**TAKE NOTICE THAT A REGULAR MEETING
OF THE BOARD OF COMMISSIONERS
OF THE CITY OF PHARR, TEXAS
WILL BE HELD AT CITY HALL, COMMISSIONERS' ROOM,
118 S. CAGE BLVD., 2ND FLOOR, PHARR, TEXAS
COMMENCING AT 4:00 PM ON
MONDAY, DECEMBER 1, 2025**

E) Consideration and action, if any, on Change Order Number 2 in the amount of \$49,781.94 and the addition of 15 working days to the construction contract with D. Wilson Construction Company for the Donation Acceptance Program for Fiscal Year 2016. **This item supports IF - Infrastructure.** (ENGINEERING)

**Project: 24-235 Pharr FY16 DAP - Agricultural
Lab, Dock Expansion I & II**
9901 S Cage Blvd
Pharr, Texas 78577

ENLARGED UTILITY PLAN

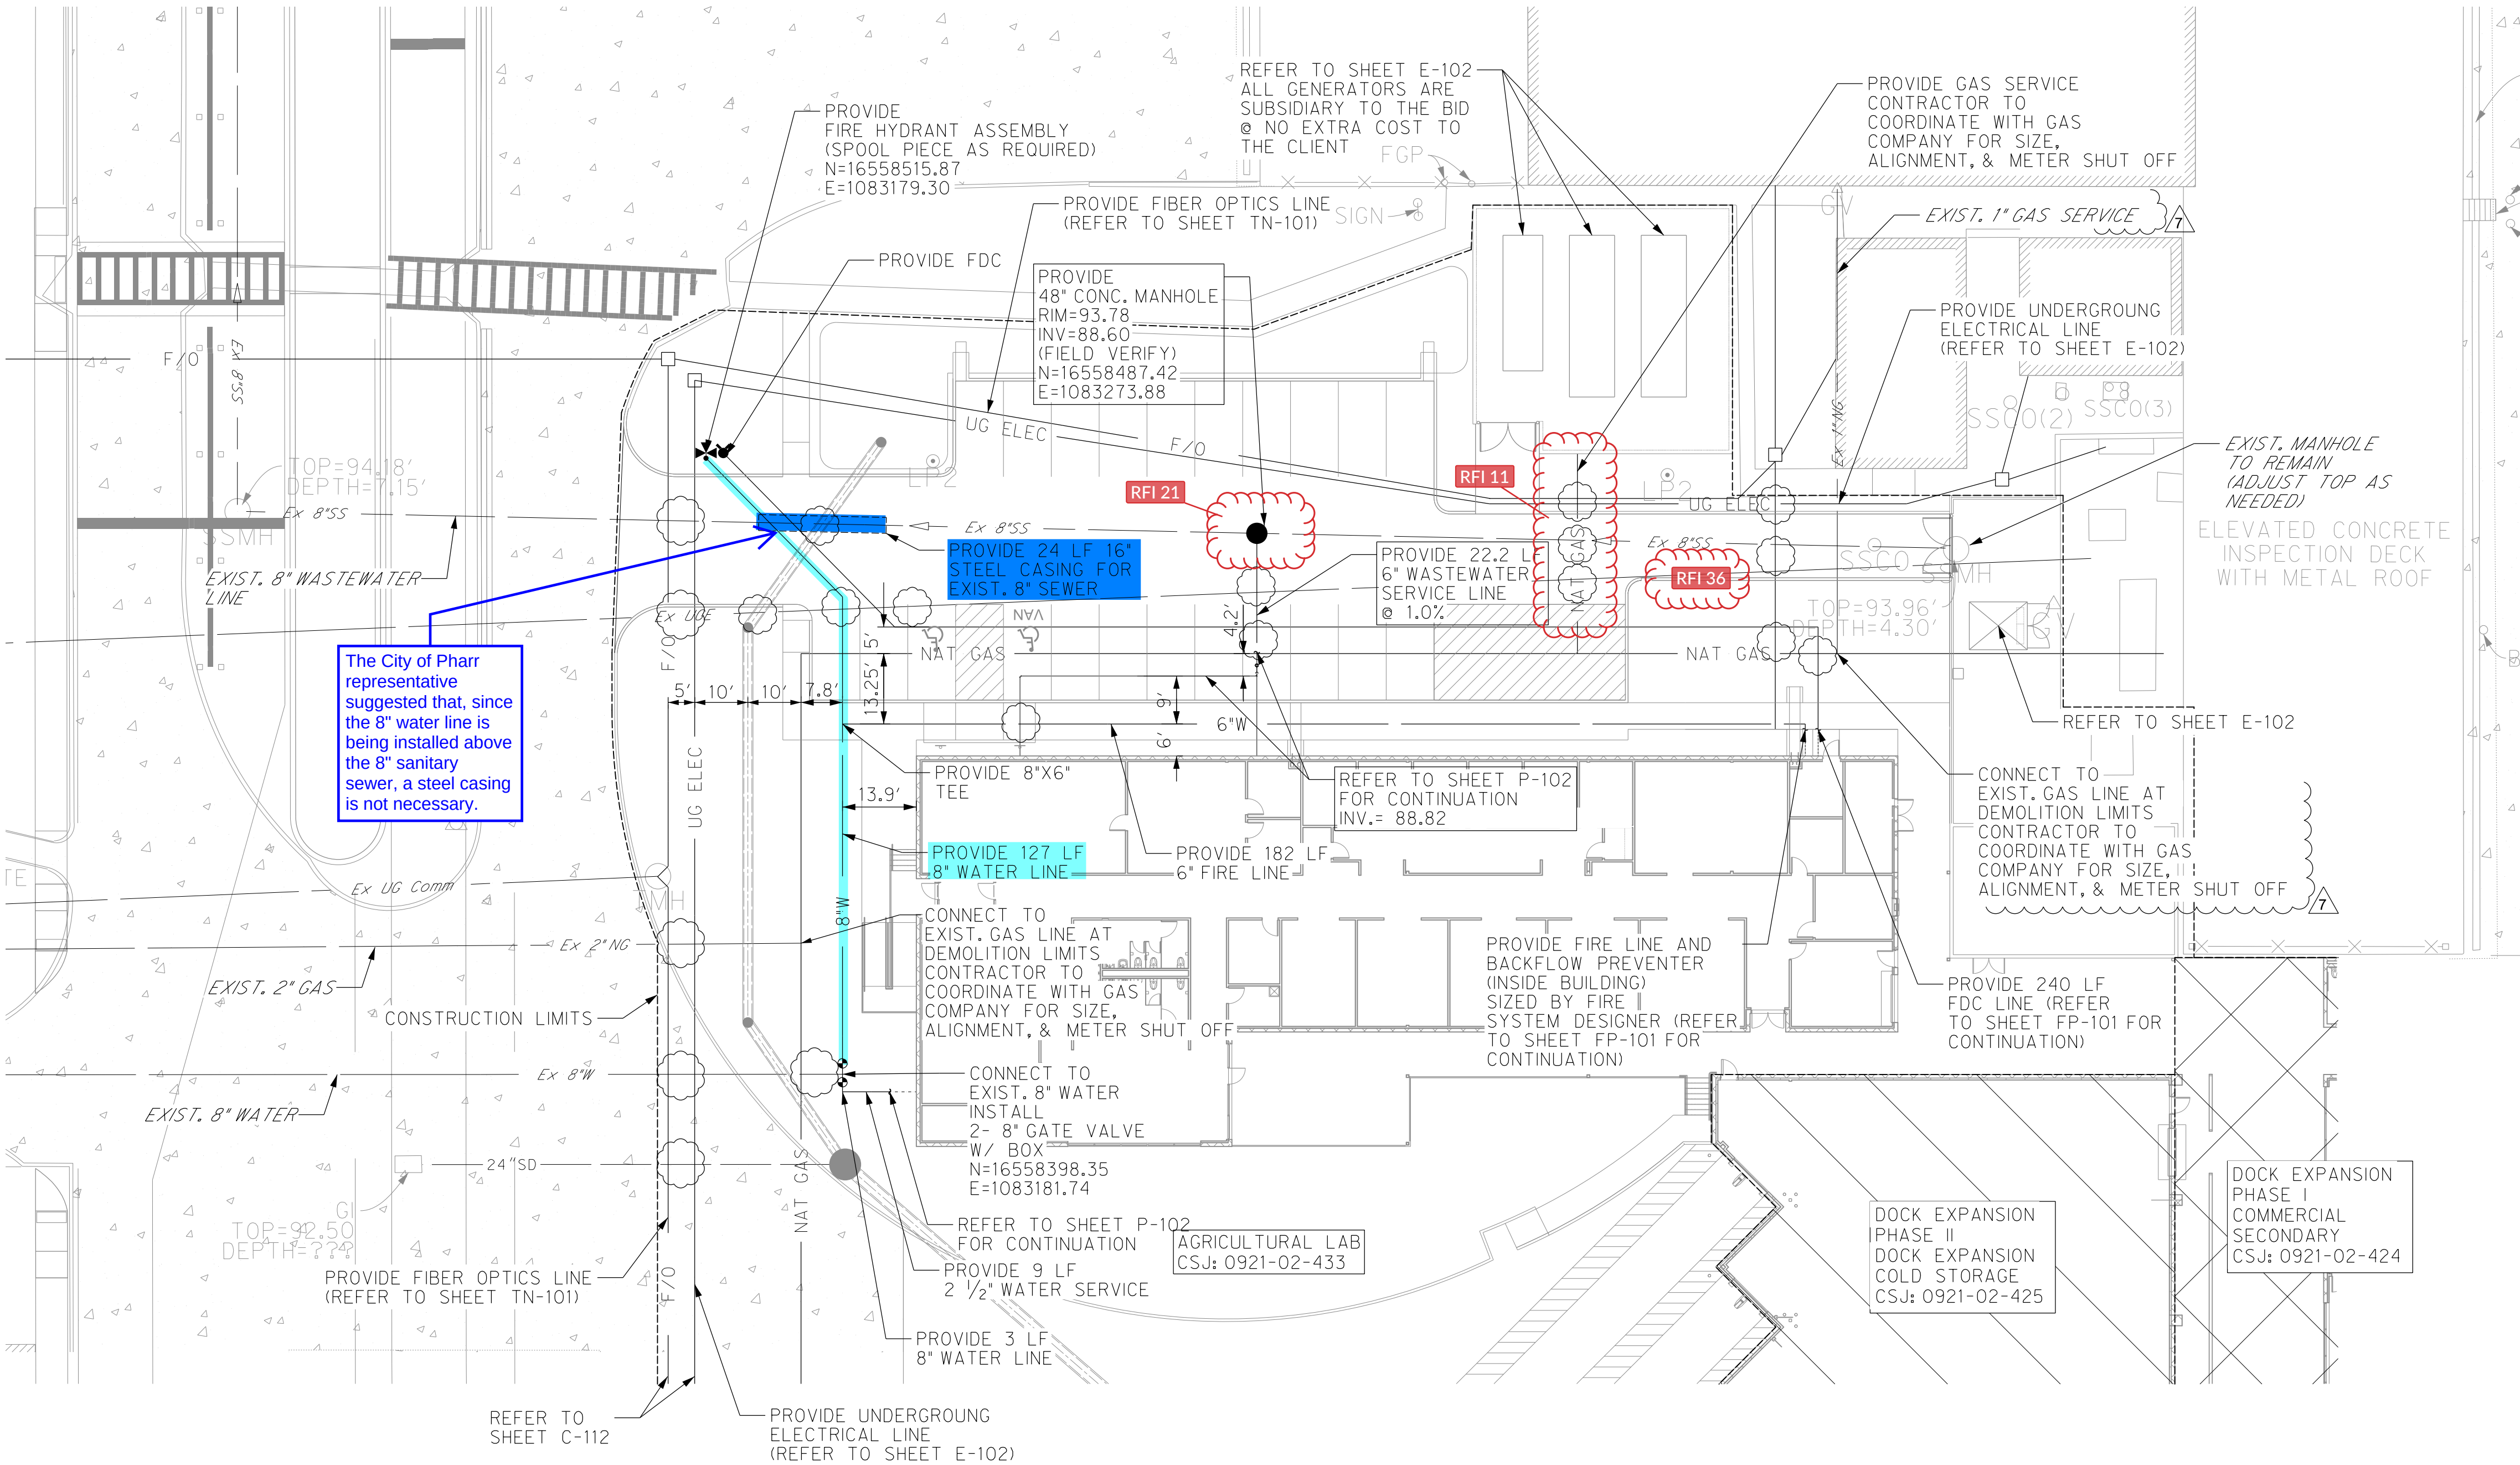
Per Civil Drawing C-402, a steel casing is called out for the existing 8" sanitary sewer. However, during an on-site walk with the City of Pharr Public Utilities representative, it was suggested that the casing may not be necessary due to the vertical separation between the new 8" water line and the existing sanitary sewer line. Since the proposed 8" water line is being installed above the existing sanitary sewer, the City does not anticipate a conflict that would require the casing. Please confirm if the construction team is permitted to proceed without installing the steel casing for the existing 8" sanitary sewer

ENLARGED UTILITY PLAN

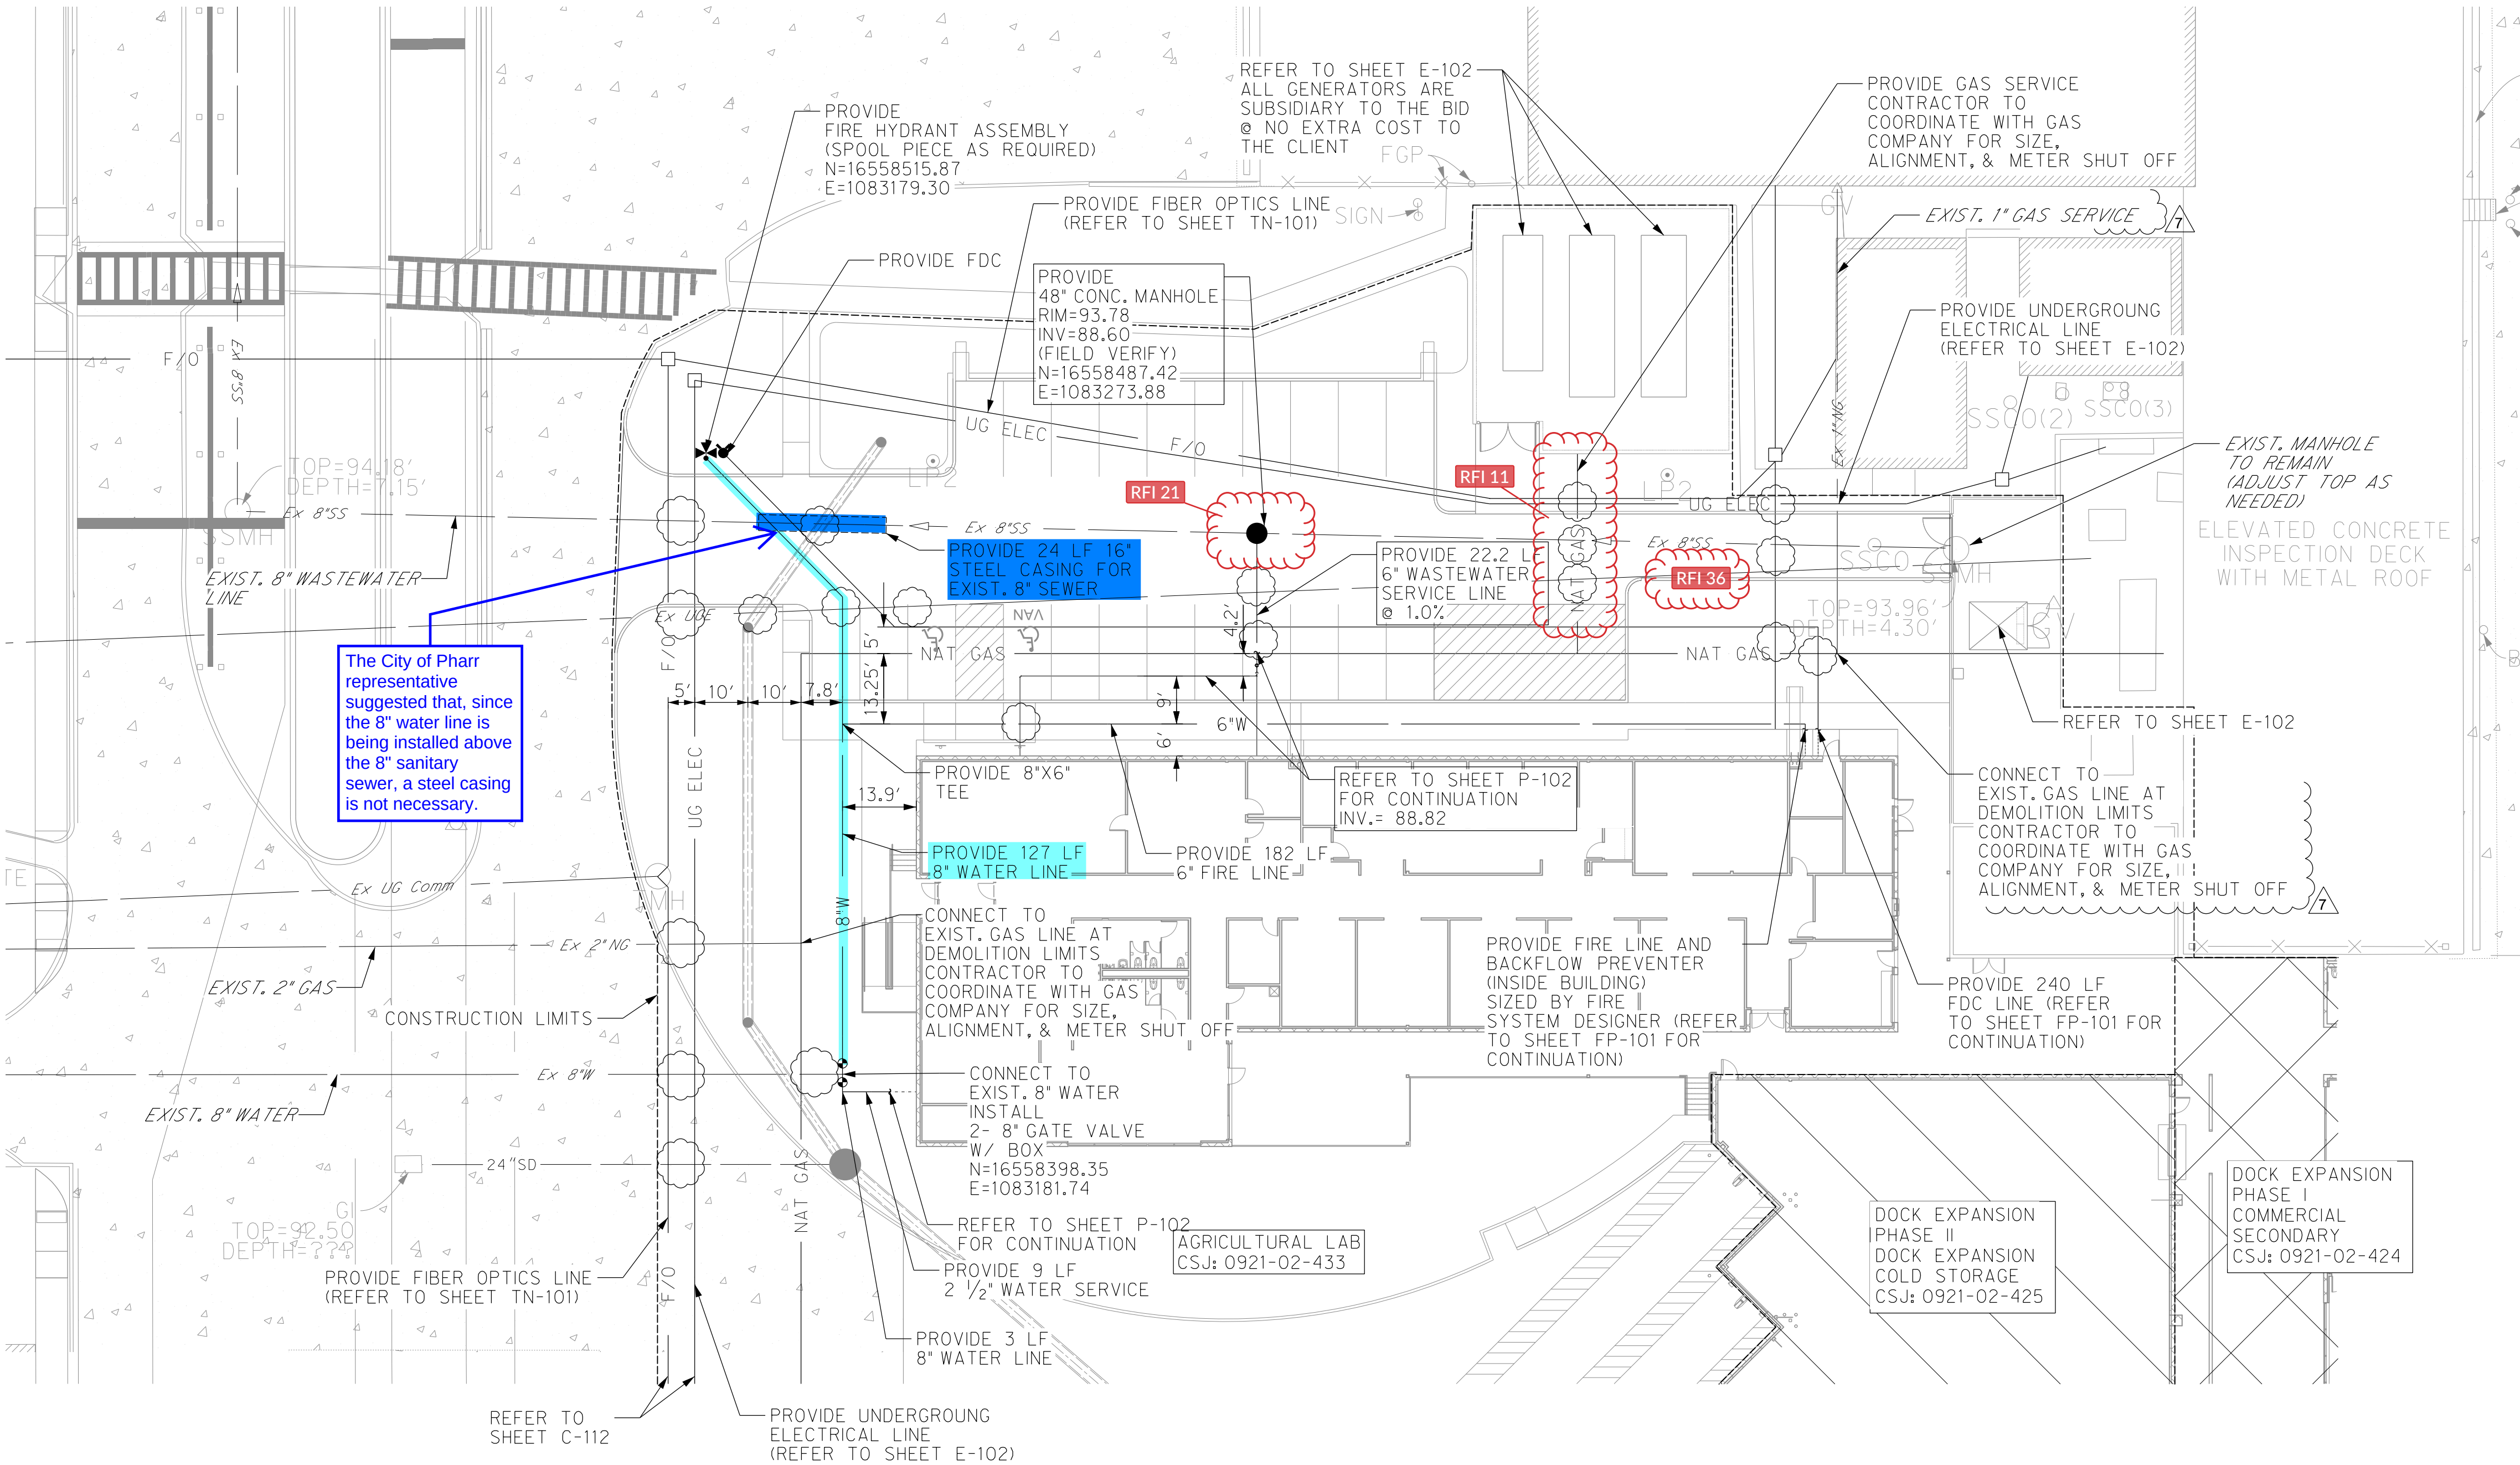
Per Civil Drawing C-402, a steel casing is called out for the existing 8" sanitary sewer. However, during an on-site walk with the City of Pharr Public Utilities representative, it was suggested that the casing may not be necessary due to the vertical separation between the new 8" water line and the existing sanitary sewer line. Since the proposed 8" water line is being installed above the existing sanitary sewer, the City does not anticipate a conflict that would require the casing. Please confirm if the construction team is permitted to proceed without installing the steel casing for the existing 8" sanitary sewer

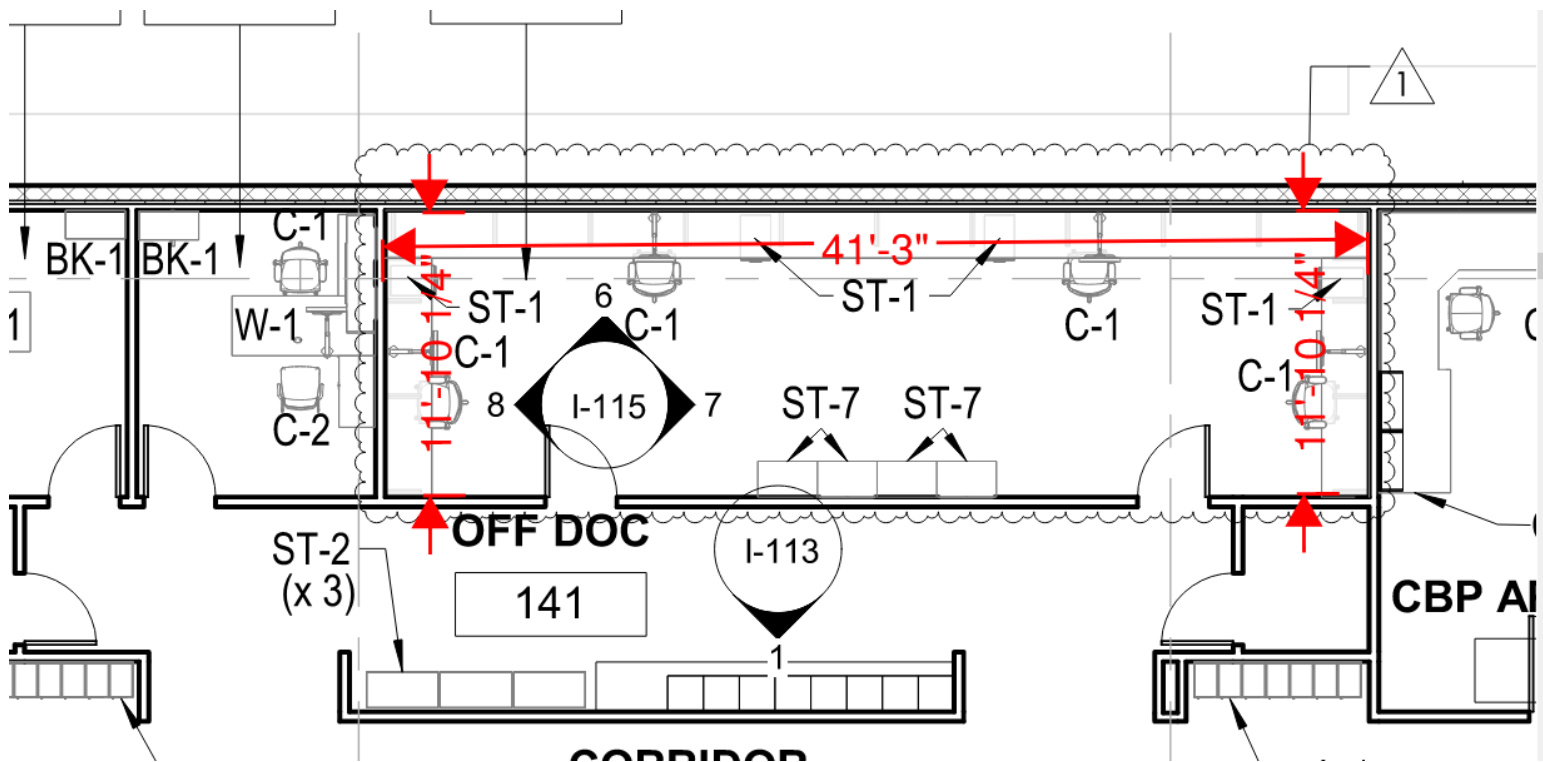
Change Proposal Request 01 - Four of the proposed initially enclosed office spaces inside the Agriculture Lab building are to be modified and converted into a single large open-area office space with four individual workstations

13 STOREFRONT TYPE - M
1/4" = 1'-0"

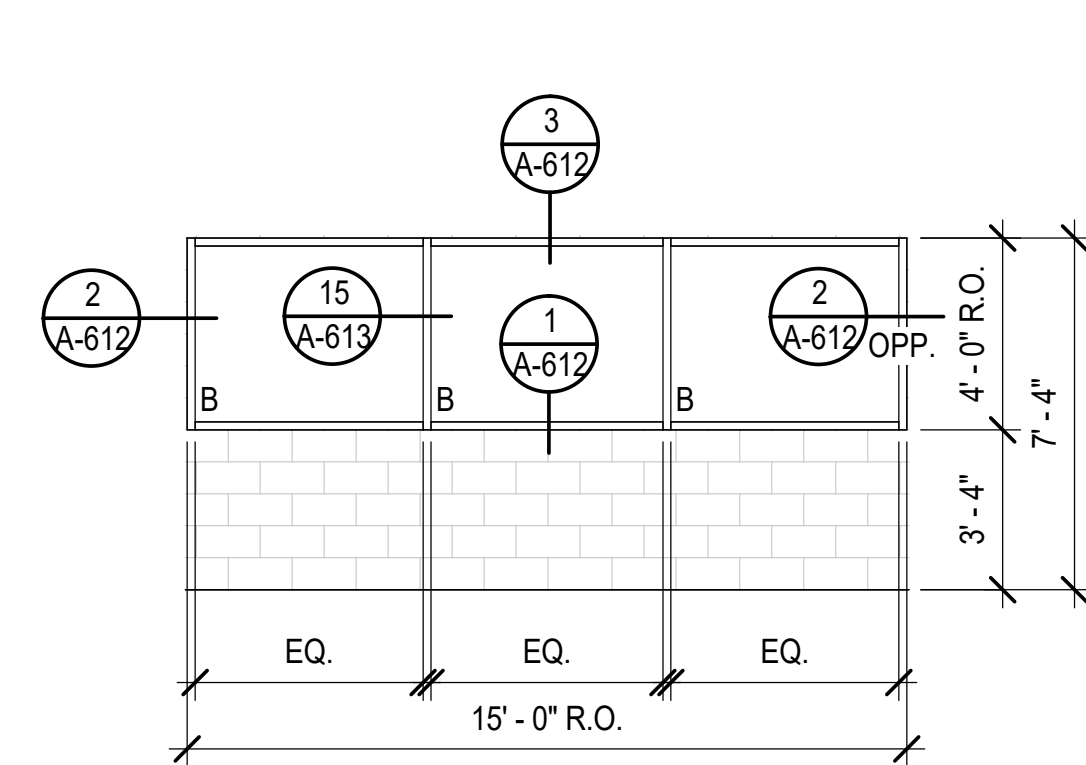
Please clarify whether the storefronts and doors highlighted in yellow on sheets 1/A-111, 1/A-112, and 1/A-114 in the attached document are required to meet Bullet Resistance Level 3. The storefronts and doors highlighted in green have been identified as bullet-resistant per sheets A-601 and A-611. Should any changes to the storefronts or doors be necessary, please provide revised drawings.

- The storefronts and doors highlighted in yellow on sheets 1/A-111 and 1/A-114 in the attached RFI document from the Contractor are not required to meet Bullet Resistance Level 3.
- Storefront 'M' and Door '161A' (highlighted in yellow) in Room 'Brokers 161' on Sheet A-112 are required to meet Bullet Resistance Level 3 (to match the rest of this building).
- All other doors highlighted in yellow on sheet 1/A-112 are not required to meet Bullet Resistance Level 3.

Attached are revised Sheets A-601 & A-611 describing the modifications.
The Plan Sheets are unaffected.
